To: Ann Arbor Planning Commission Members

Re: Lockwood Rezoning PUD

Lockwood Infiltration

Gelman cross-section 20080410-EG-Xsect-08-11 (3459 Ferry, 3402 Ferry -GSI-98-02-3409 Ferry-Mw 30d+i) overlaid hand drawn Lockwood cross section (MW-118, MW-30d+i, MW-71)

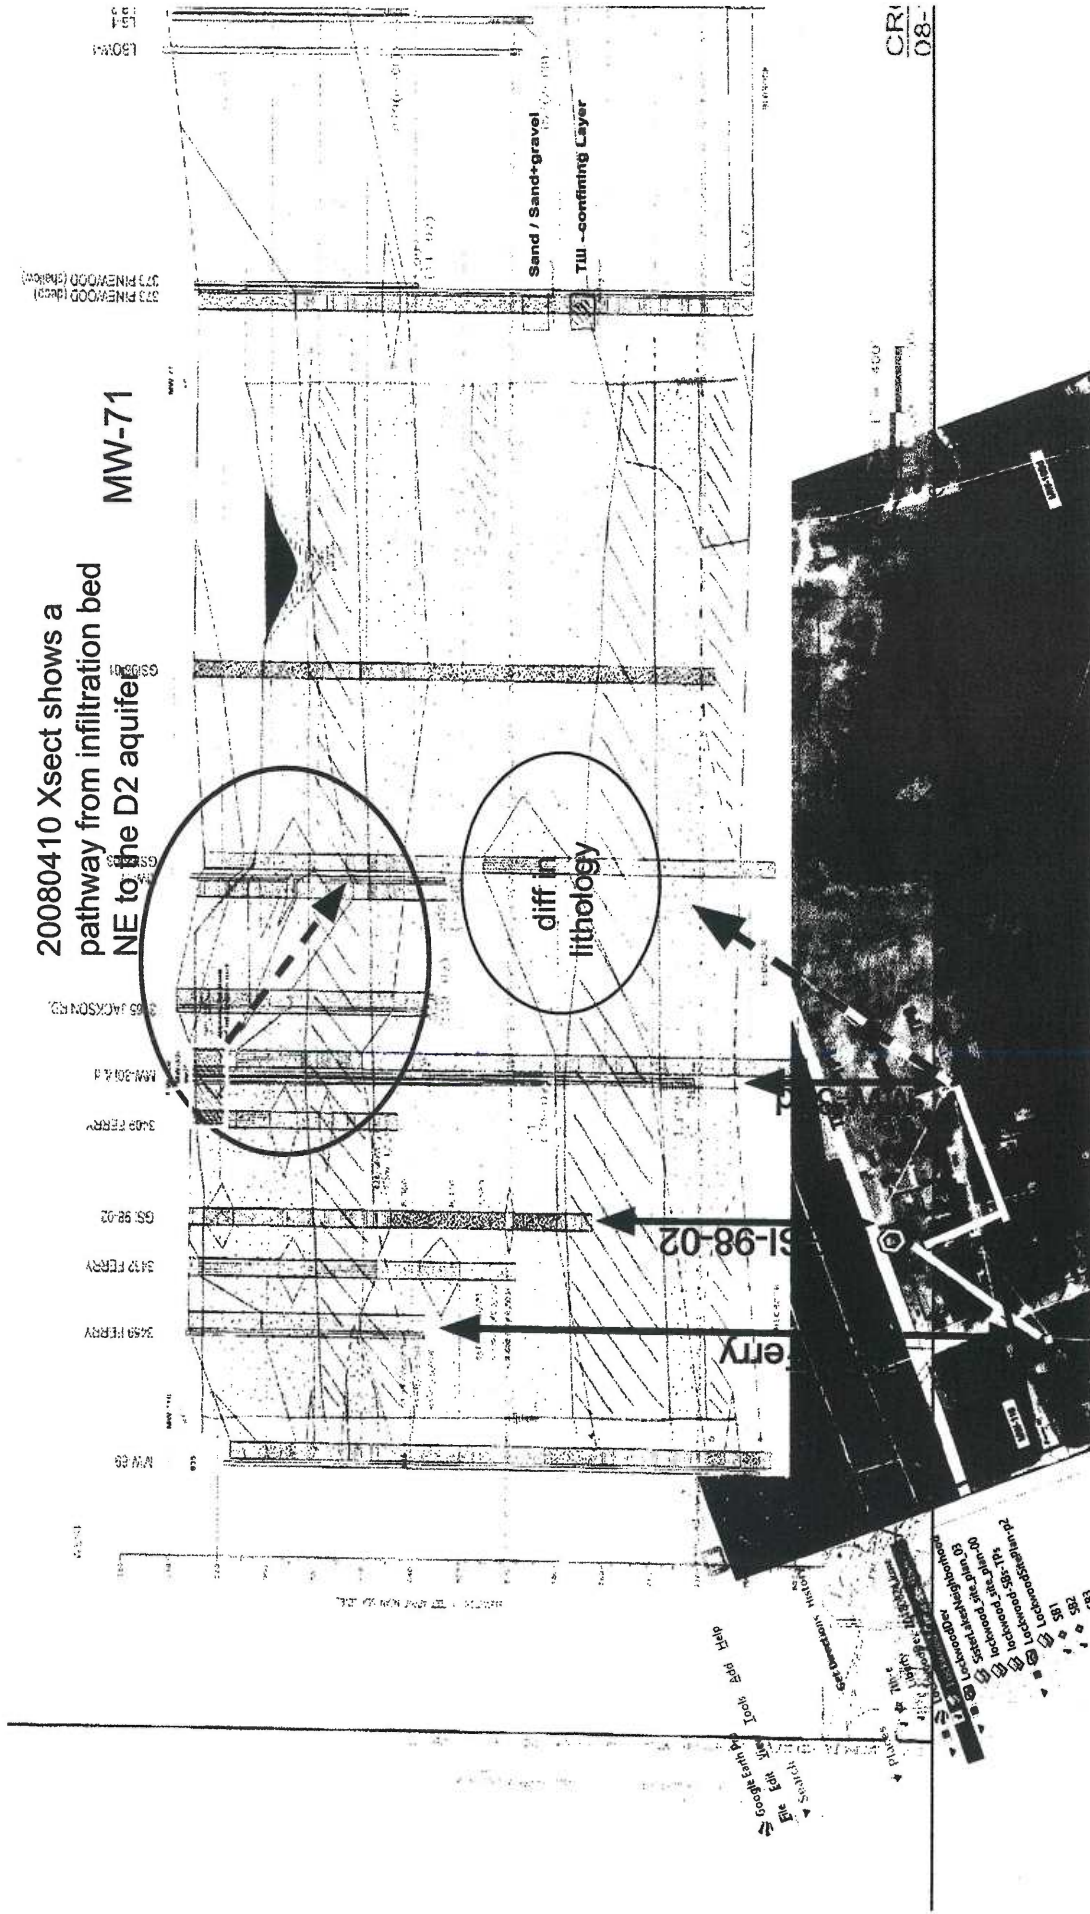
Gelman cross-section 20080410-EG-Xsect-08-11 shows a CLEAR PATHWAY from infiltration bed NE to the D-2 aquifer. The difference in lithology may be a factor too.

Lockwood proposed parcel overlaid
 on Lockwood cross-sections.

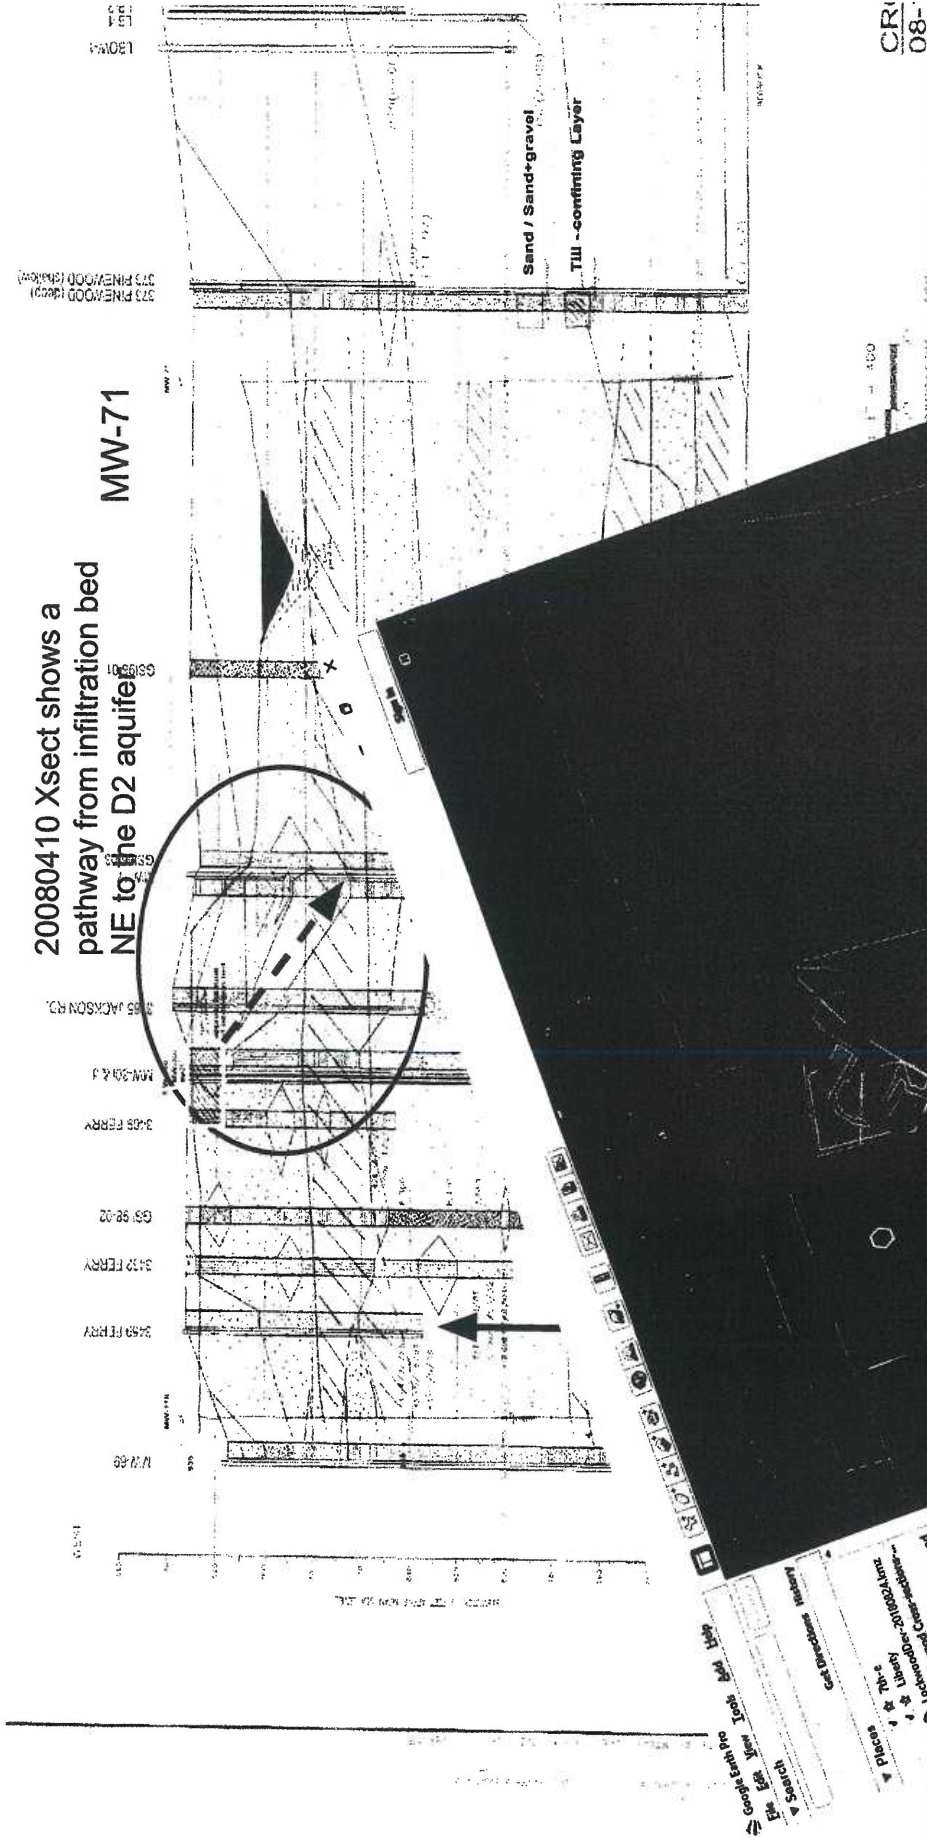
20080410 Xsect shows a
 pathway from infiltration bed
 NE to the D2 aquifer

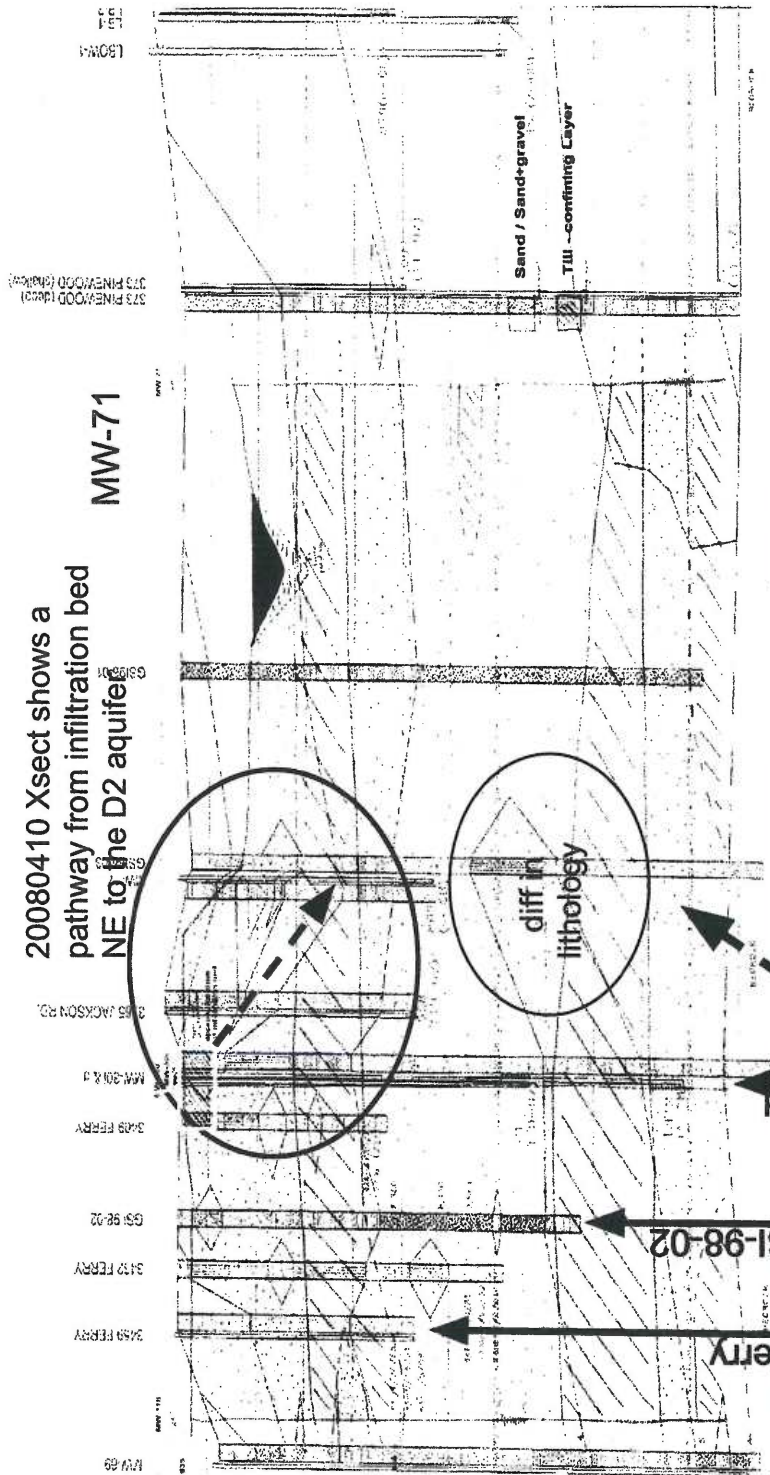
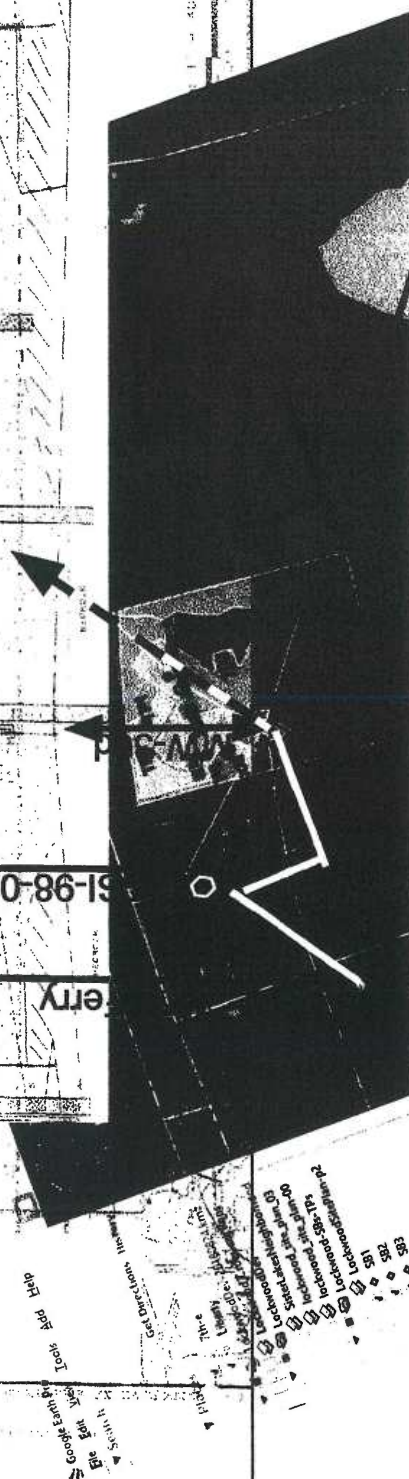
20080410 Xsect shows a
 pathway from infiltration bed
 NE to the D2 aquifer

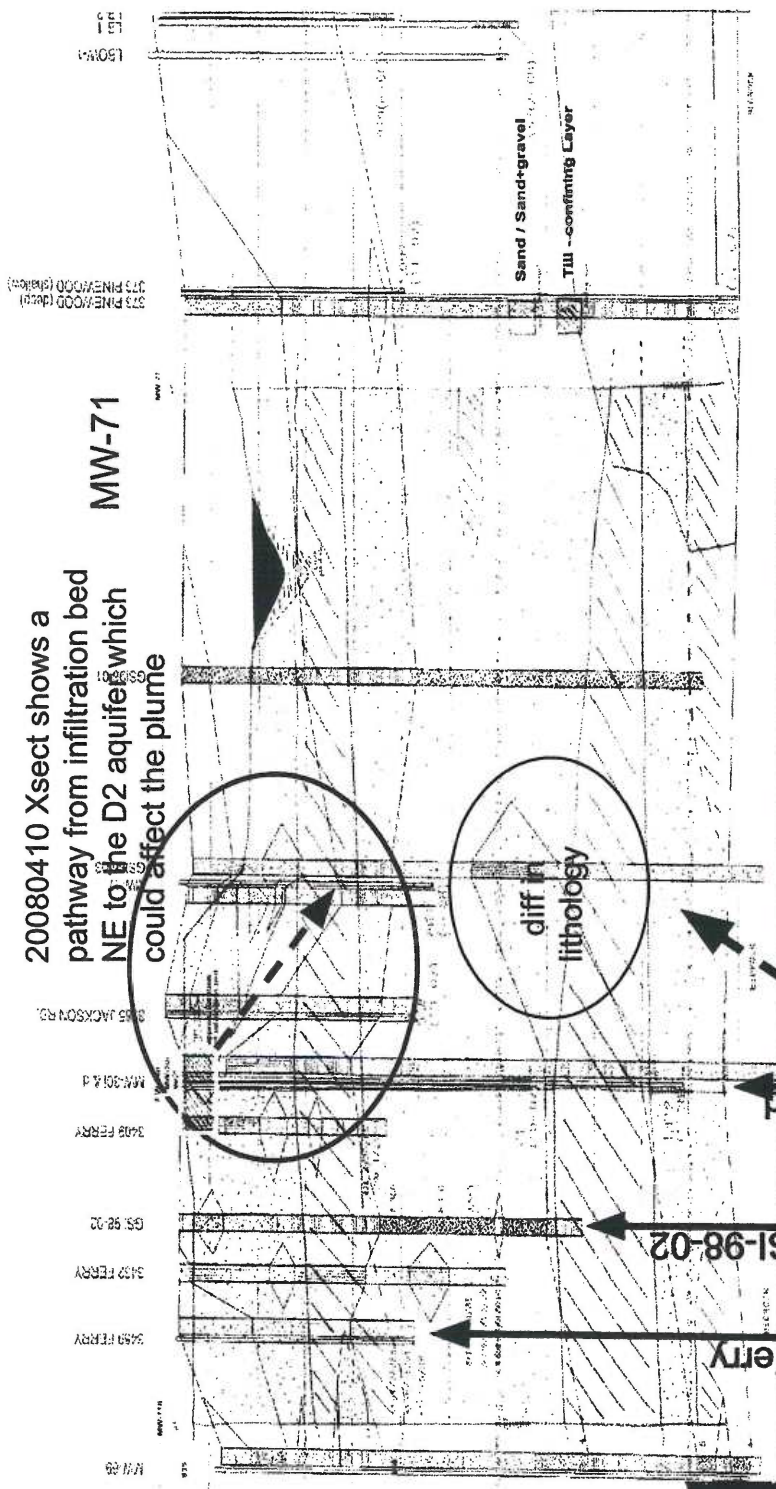
20080410 Xsect shows a pathway from infiltration bed NE to the D2 aquifer which could affect the plume

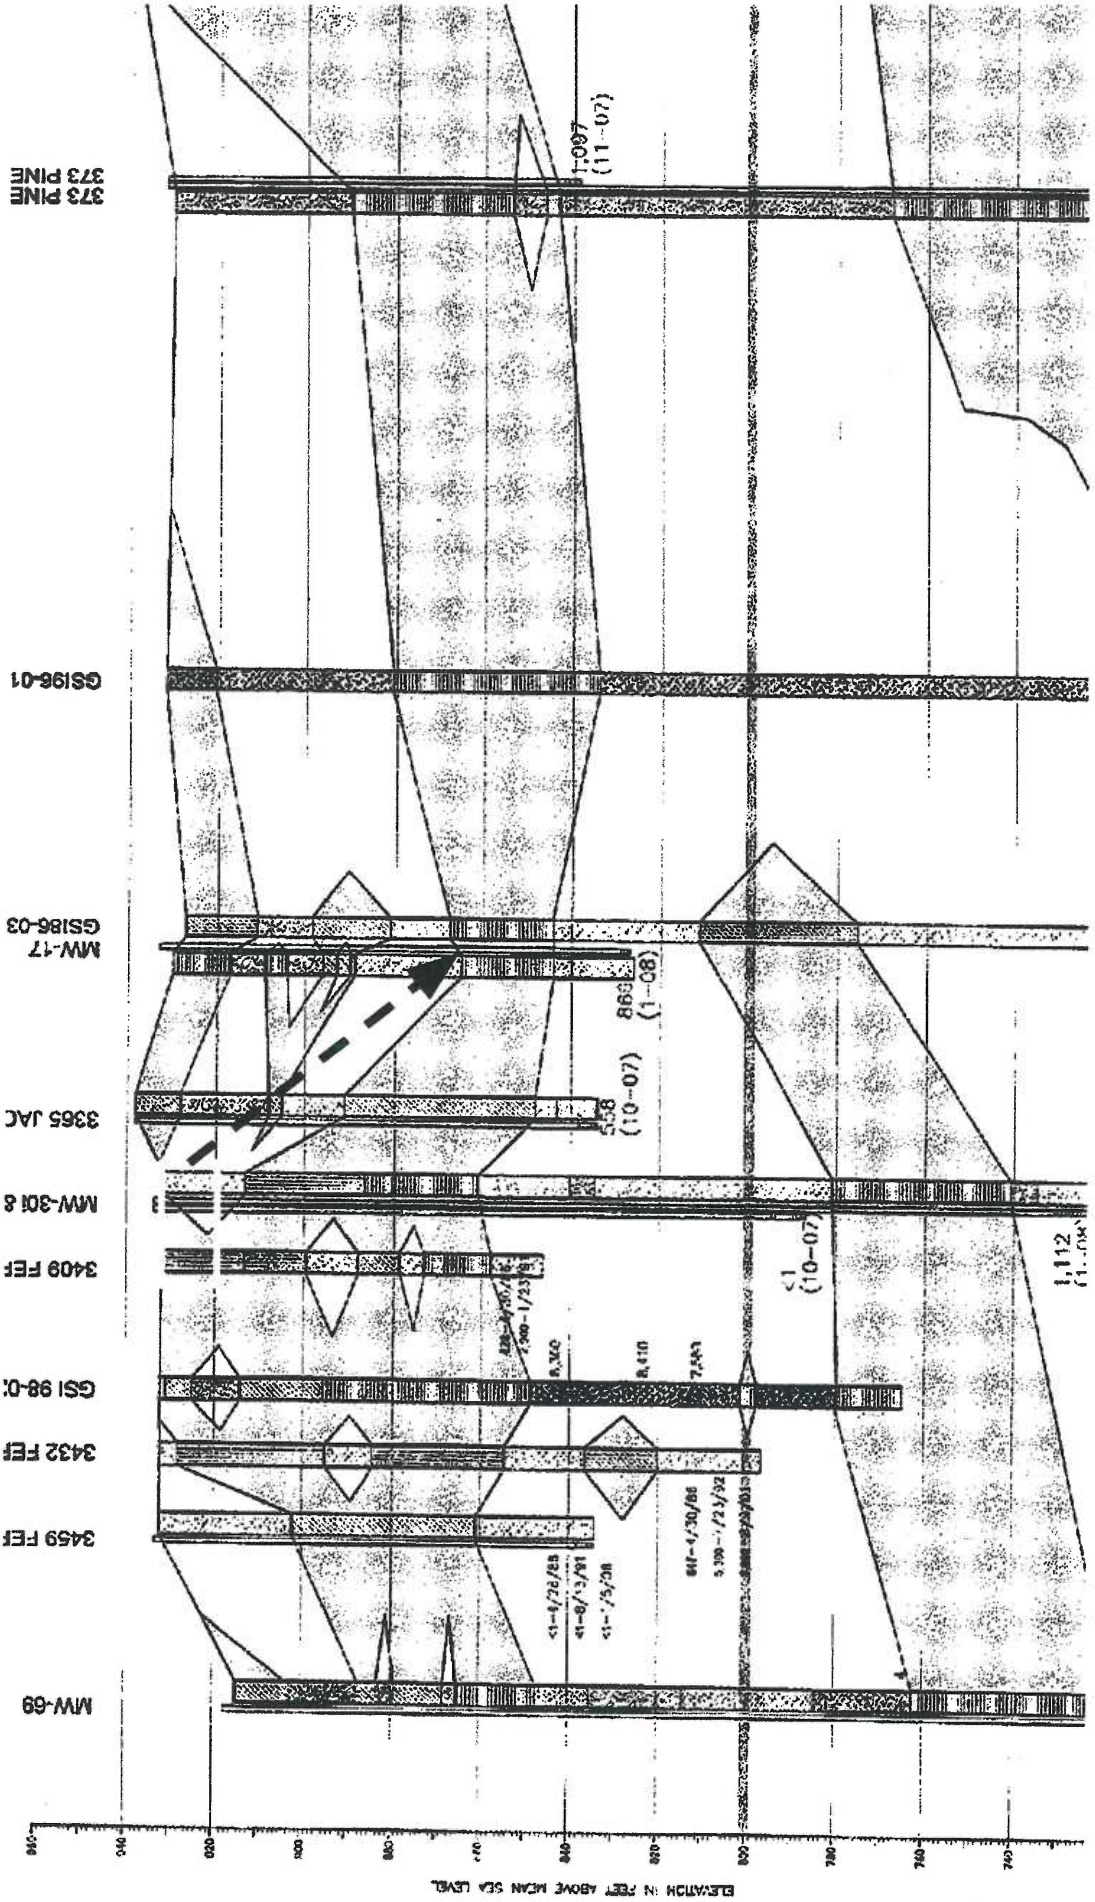
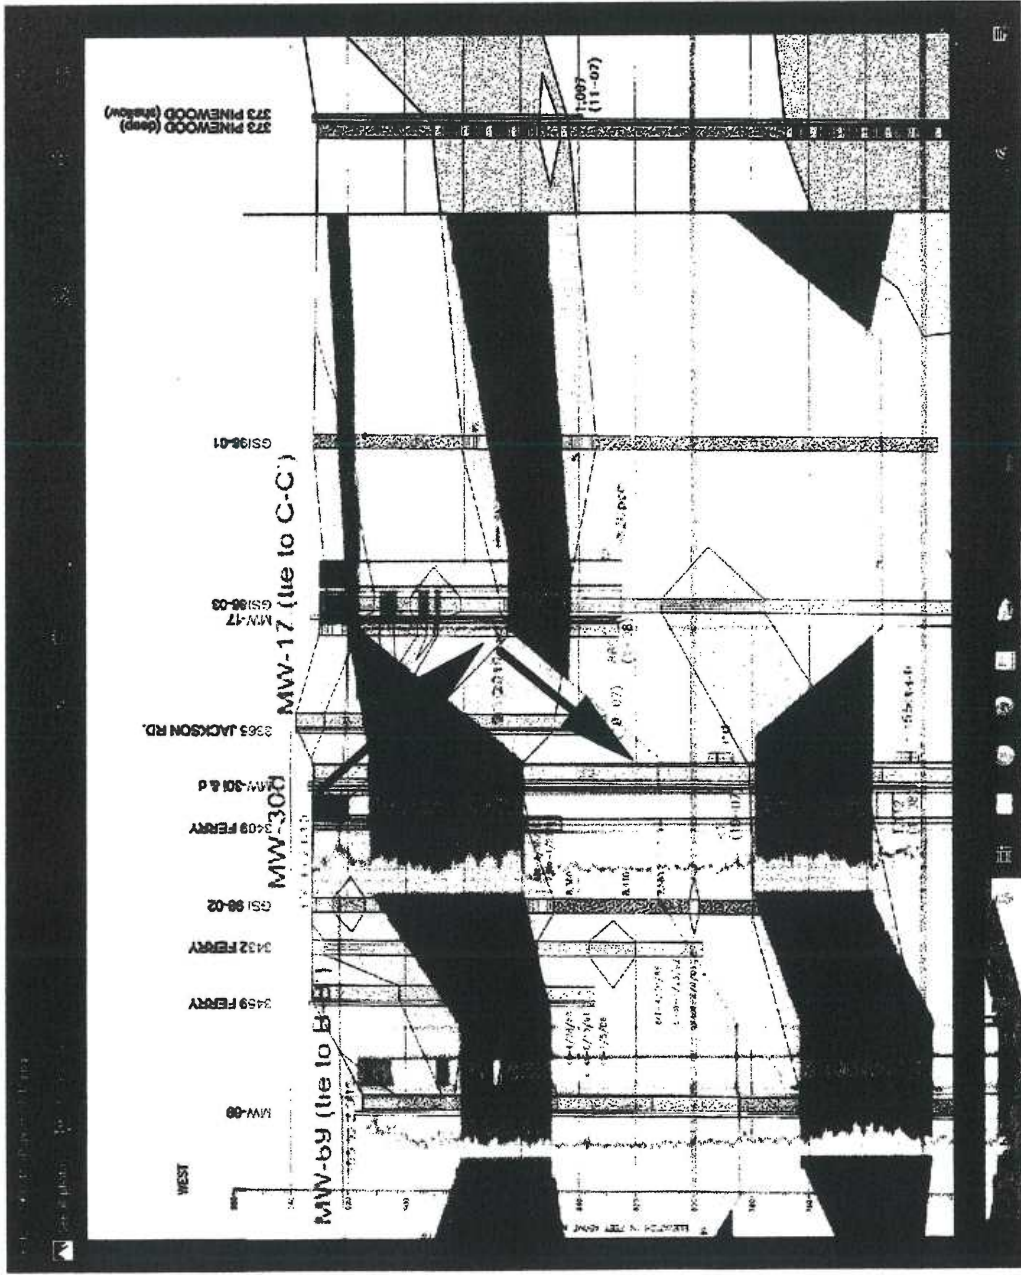
20080410 Xsect shows a
pathway from infiltration bed
NE to the D2 aquifer

20080410 X-sect shows pathway from INFILTRATION Bed to D-2 region

Combining 20080410 X-sect w/ Frabrum thesis show even MORE direct route from Infiltration bed to D-2 aquifer.
